**MEETING OF THE
PLANNING AND ZONING BOARD
QUASI-JUDICIAL PUBLIC HEARING**

July 19, 2016

1. Request for approval for a new commercial complex for "Church by the Sea" located at 1000 Kane Concourse, Tract N. The developers are proposing to construct a new 3 story mixed use development project. On May 17, 2016 the Board discussed and deferred and advised the applicant to make several changes. The Developers have made the changes as requested. The new complex proposes to have commercial retail space at the street level facing Kane Concourse. The new building is 3 stories in height @48'2" above BFE (65 feet BFE allowed). Enclosed please find the site plan and elevations. (Item #1A)

Subject: Site Development Plan Application
Church by the Sea – Mixed-Use Commercial Complex
1000 Kane Concourse
Bay Harbor Islands Acct. No. MB2016-17
MMPA Acct. No. 01-0702-1032

A-101

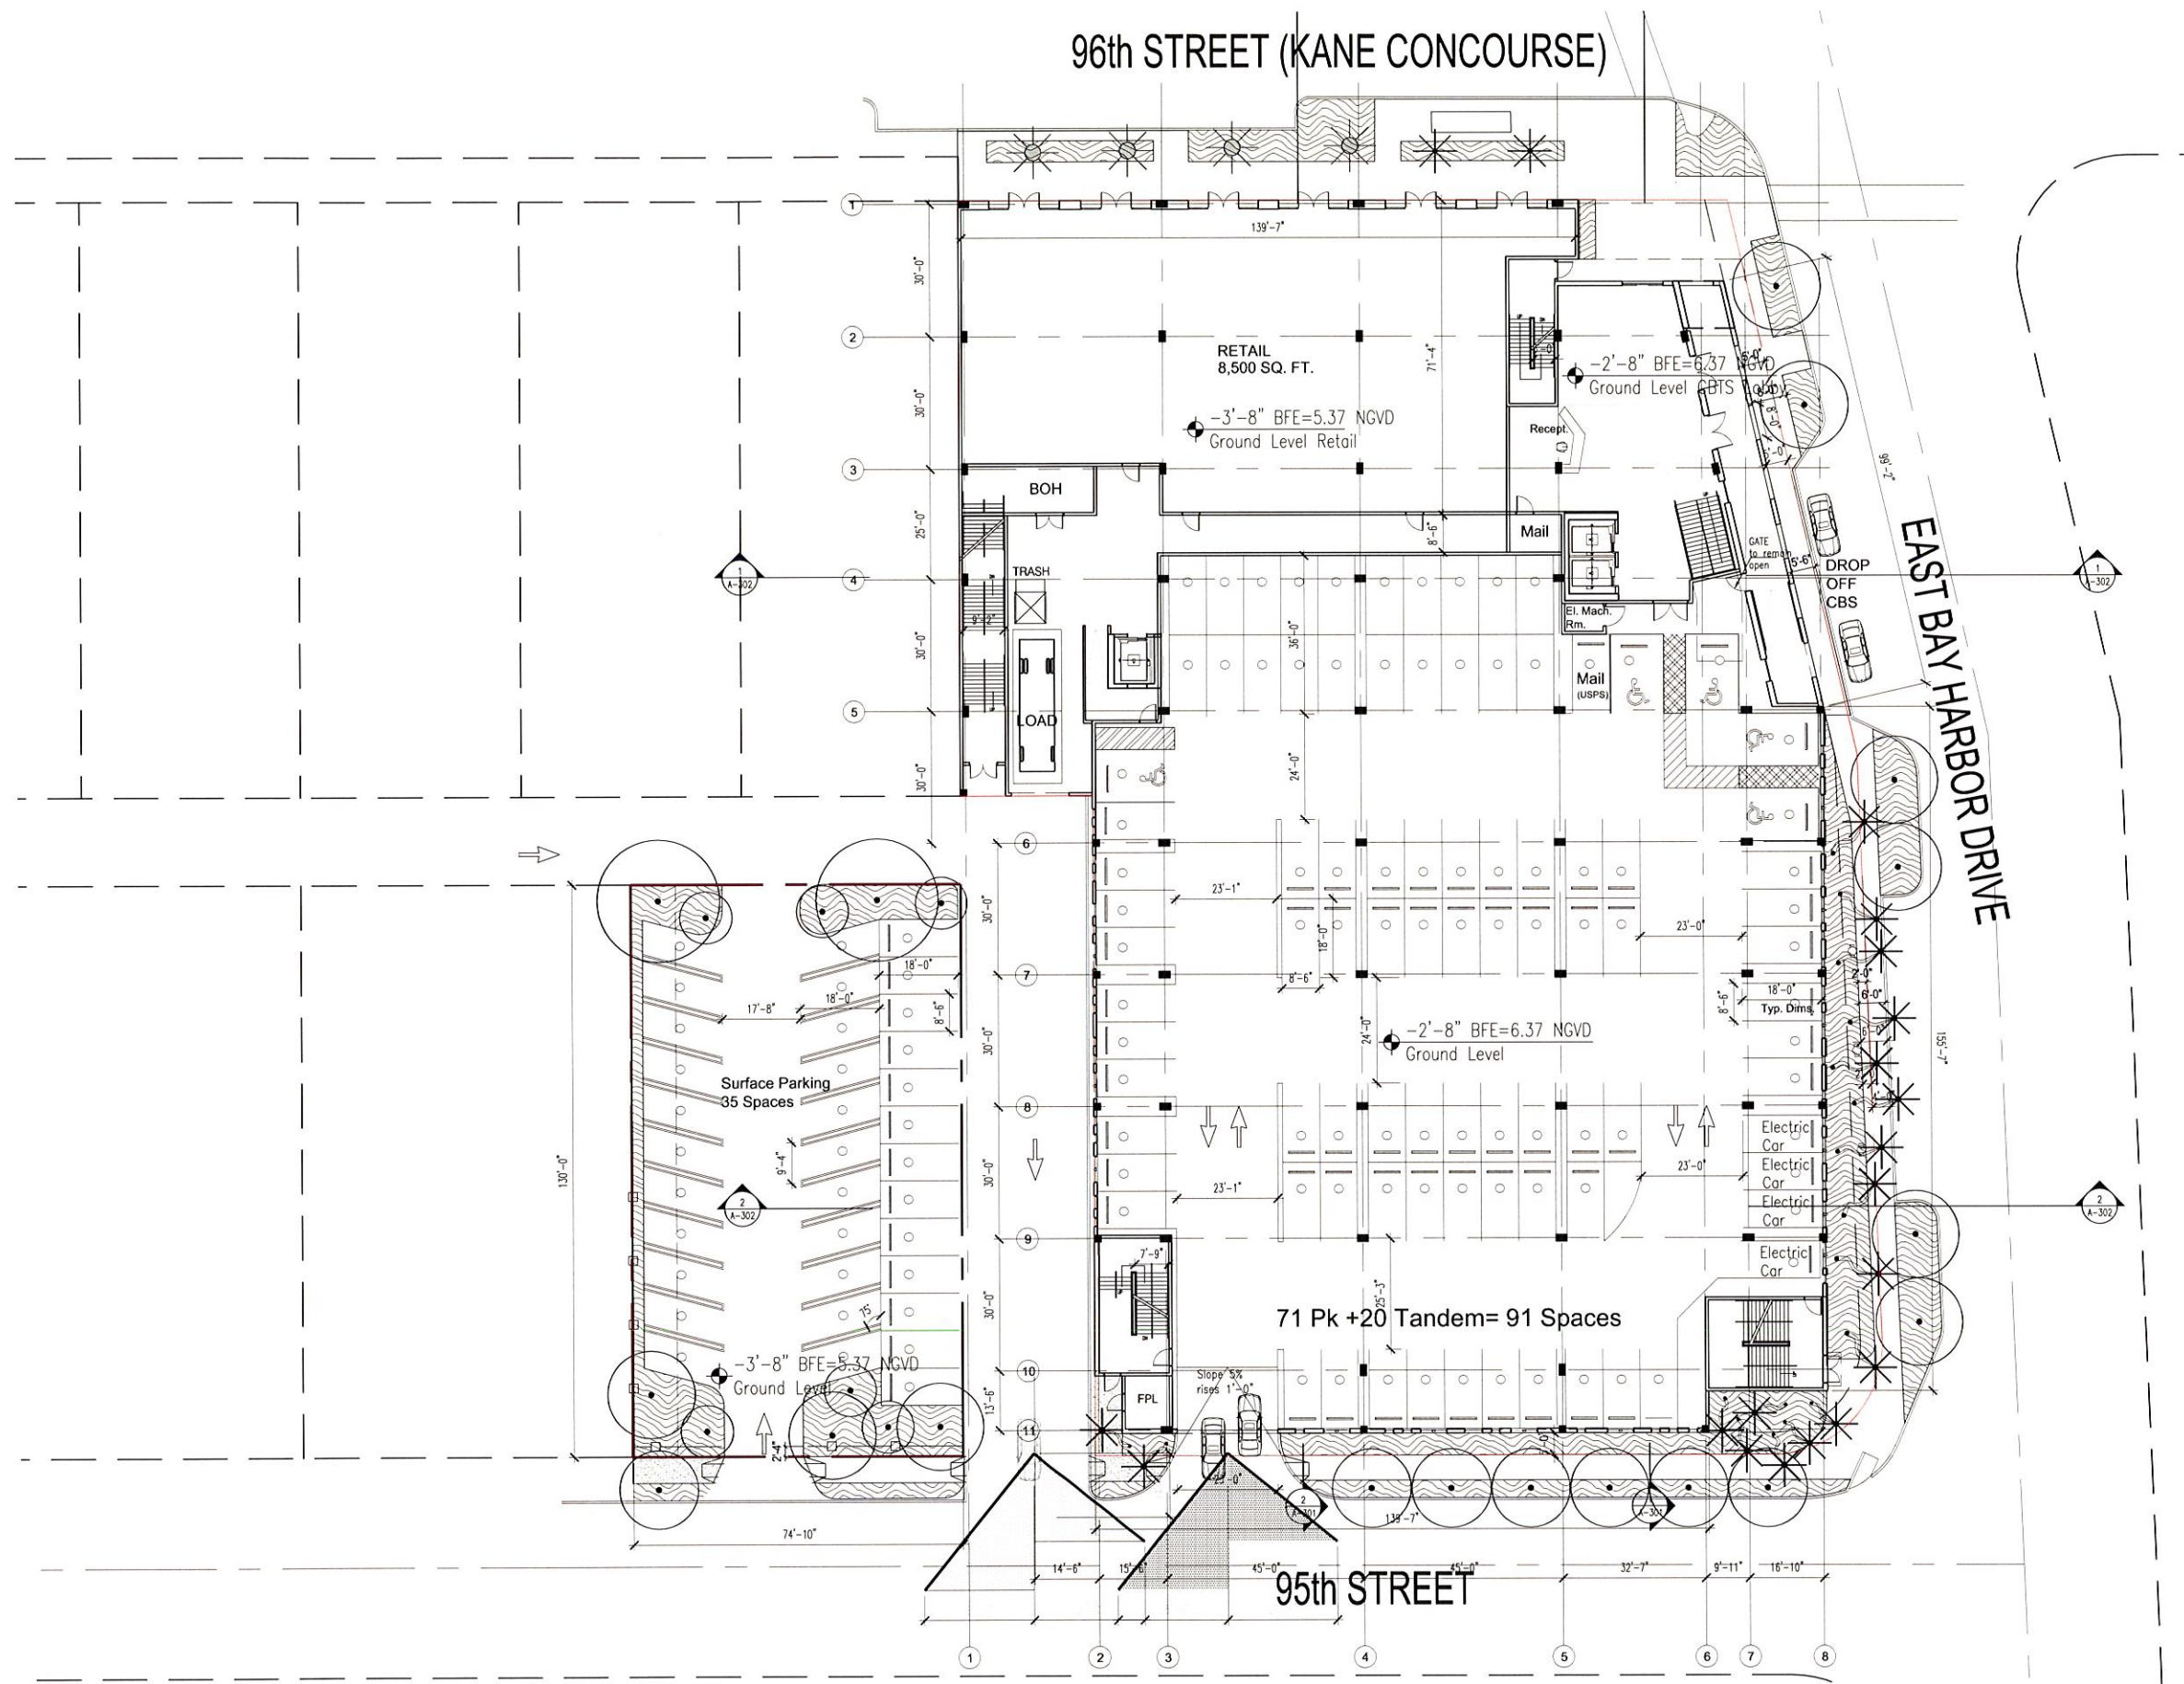
- 3) The PZ Board requested that the walkway in the southwest corner of the site be continued across the ally to the surface parking area which is now reflected on the plans. However, the exit stairs in the southwest corner of the site shows the landing in a slightly different location which does not provide access to this walkway / crosswalk (exits to the ally). Revise the plans so that this exit stair connects to the sidewalk along the street. Ensure that all landscape requirements are still met if any trees / palms are removed.

RESPONSE: We adjusted our landscape design and removed a palm to show a walkway connection between the exit door of the SW stair and the sidewalk facing 95 street. Landscape plans and sheet A-101 reflect those changes

A-703

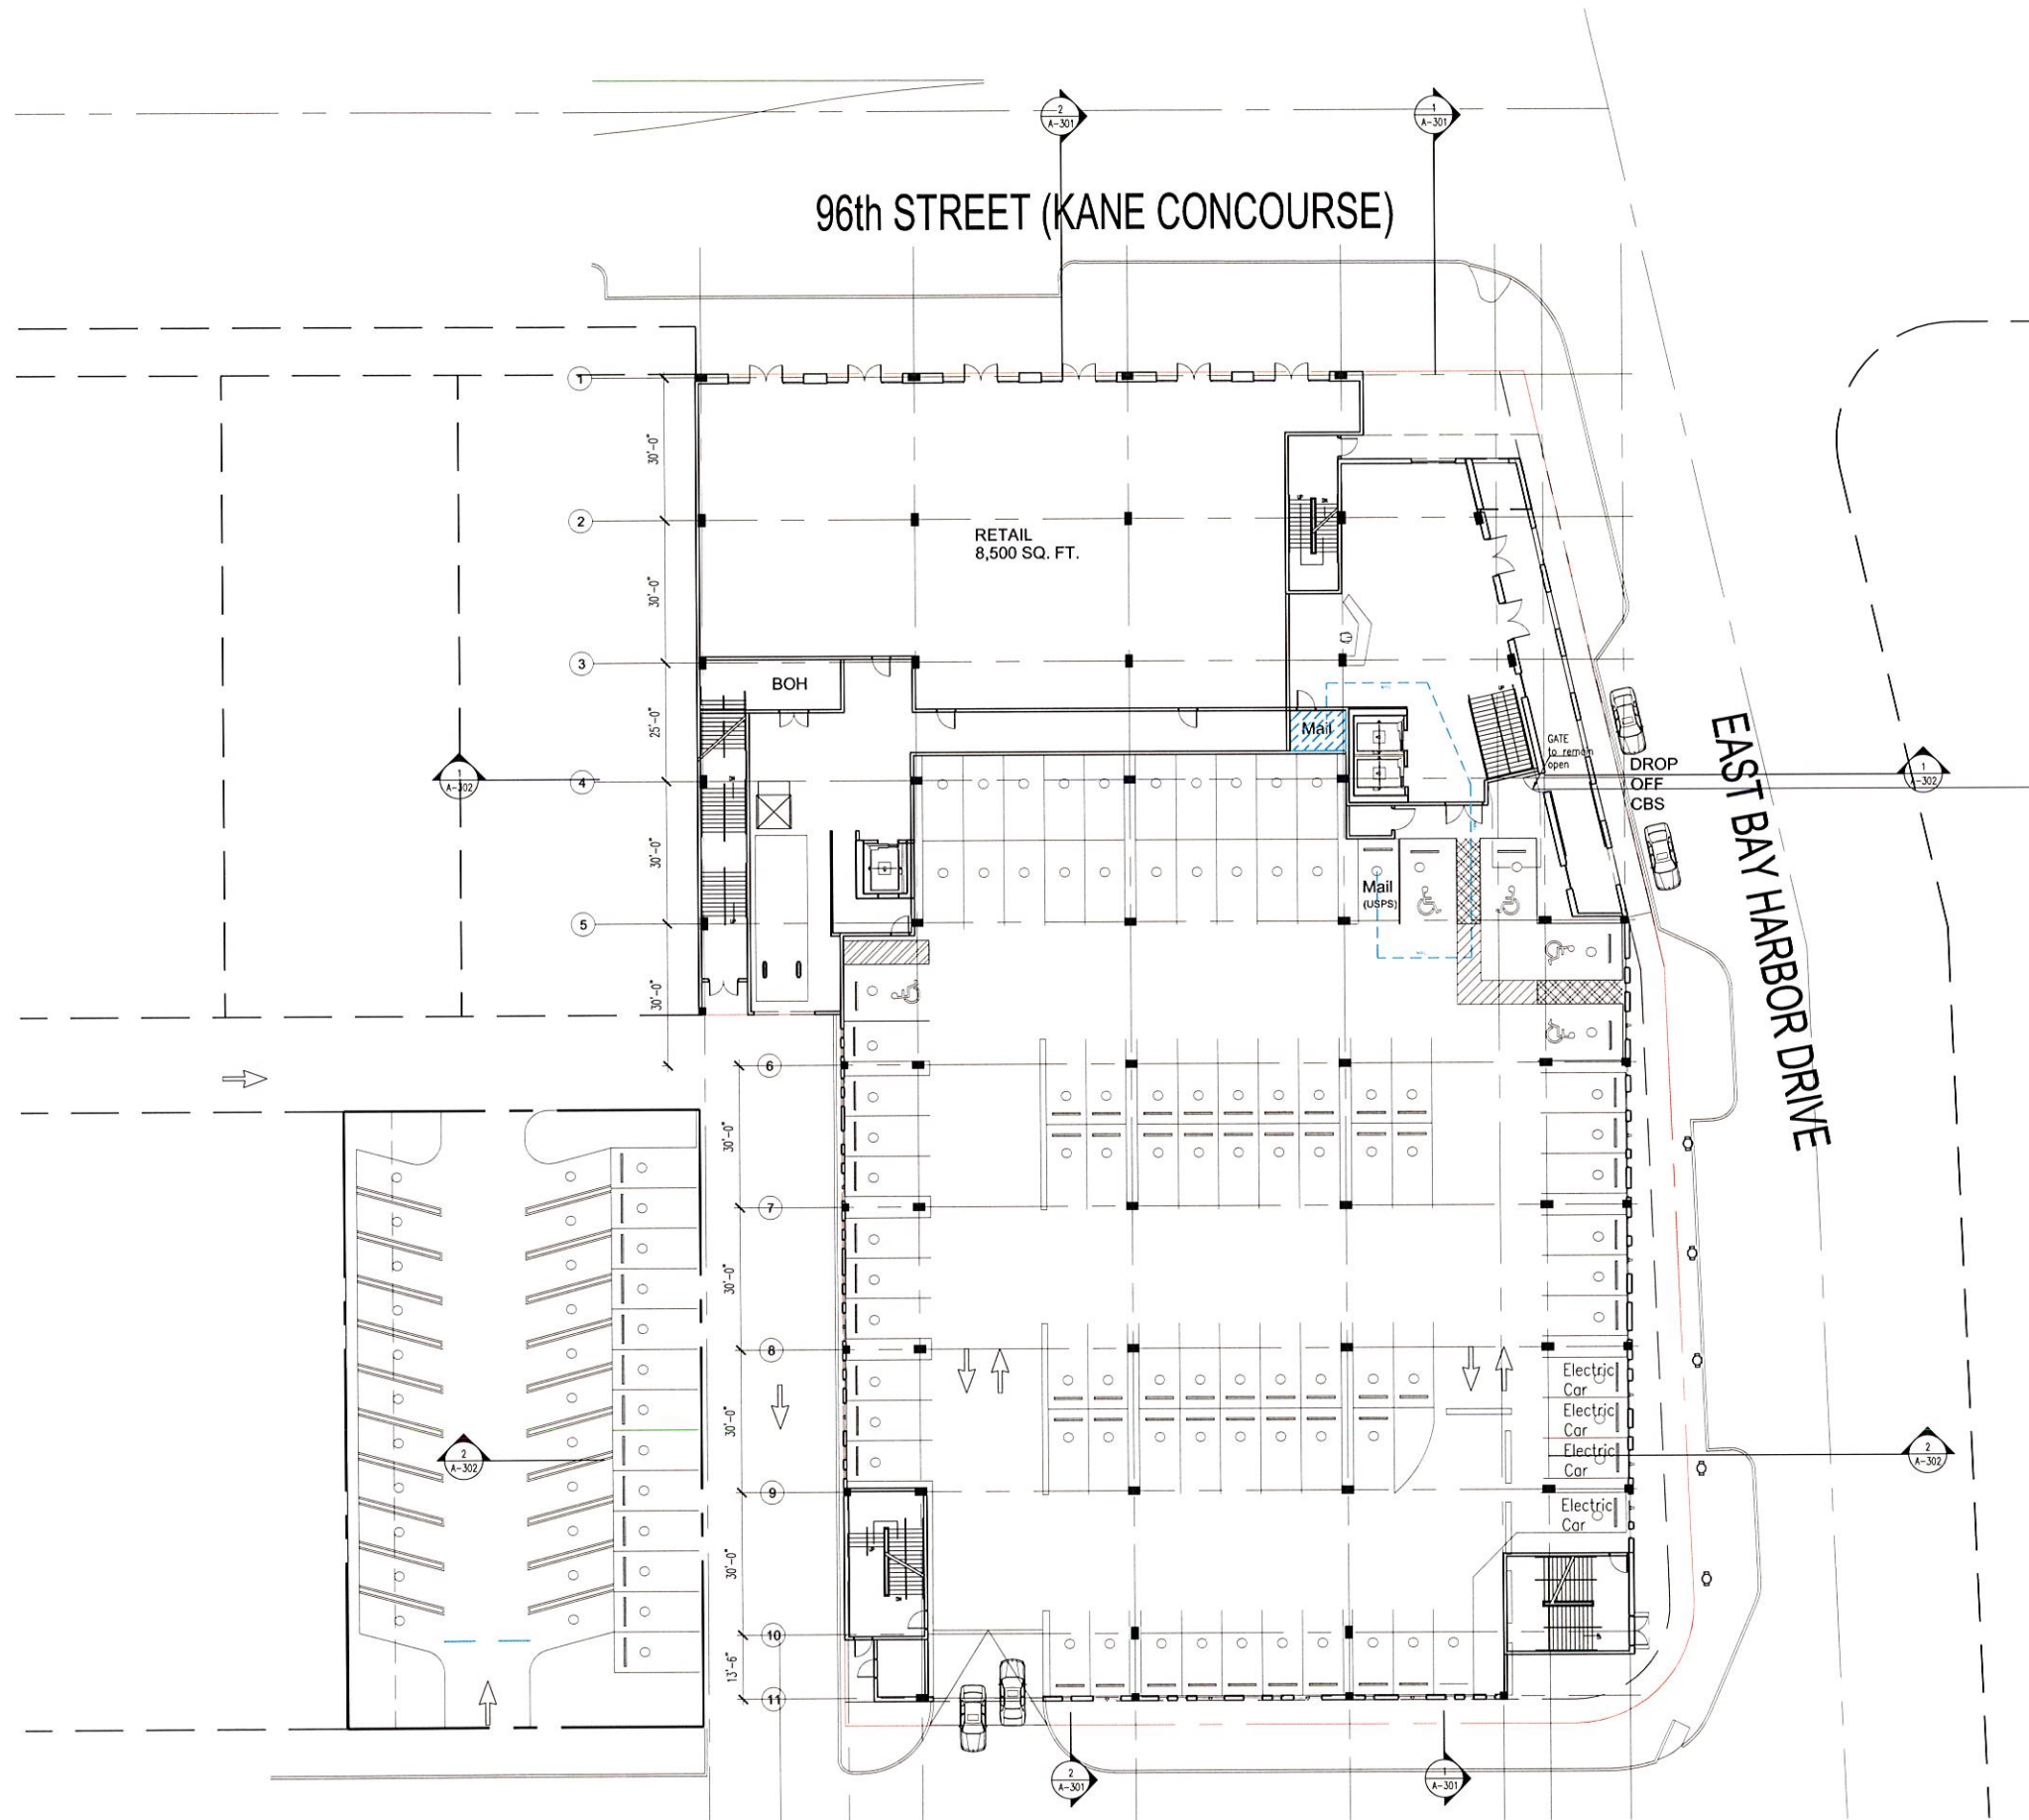
- 5) Sheet A-703 must be updated to show the revised truck movement as shown on the updated site design (stairs relocated / truck shown in stairs).

RESPONSE: Loading Path has been adjusted to new design. Refer to sheet A-703

A-705

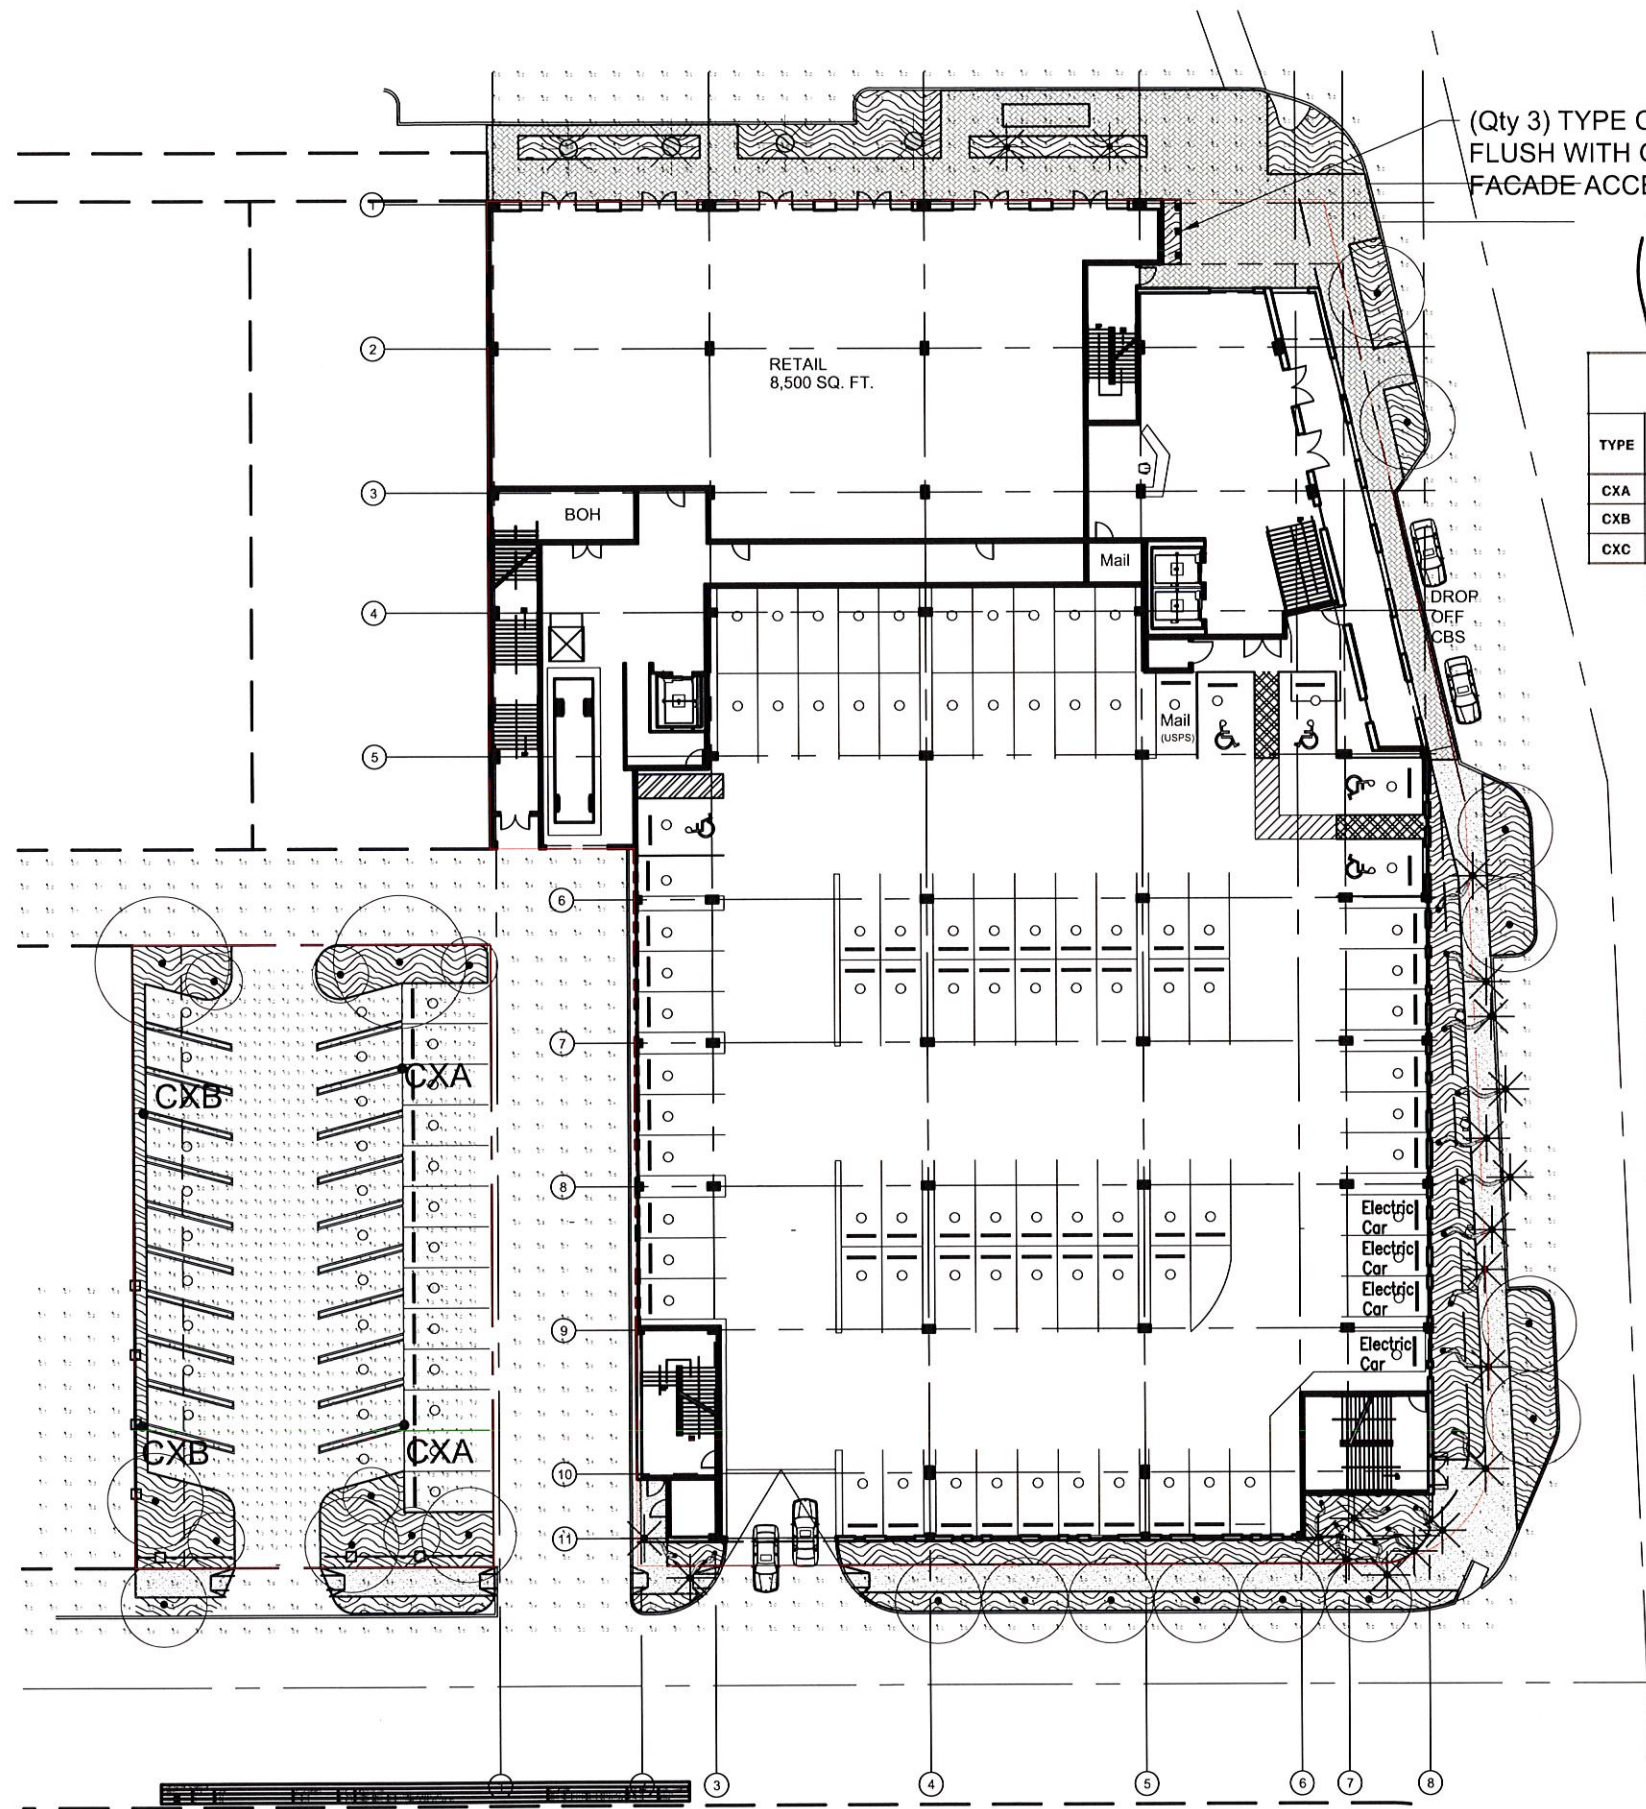
- 7) A PZ Board member expressed interest about the possible location of the shadow / reflection of the cross and wants to ensure that the reflection / shadow will occur only within the tower. Has the location of the shadow / reflection throughout the day been studied? To address this MMPA feels a diagram / study should be provided on the plans / separately to address the Board member comment.

RESPONSE: A shadow study has been produced. Refer to Sheet A-705. It shows the critical dates of summer and winter solstices at 9am, 2pm and 5pm
We will have an animation to be shown on the day of the hearing showing the entire days at those dates, if needed.
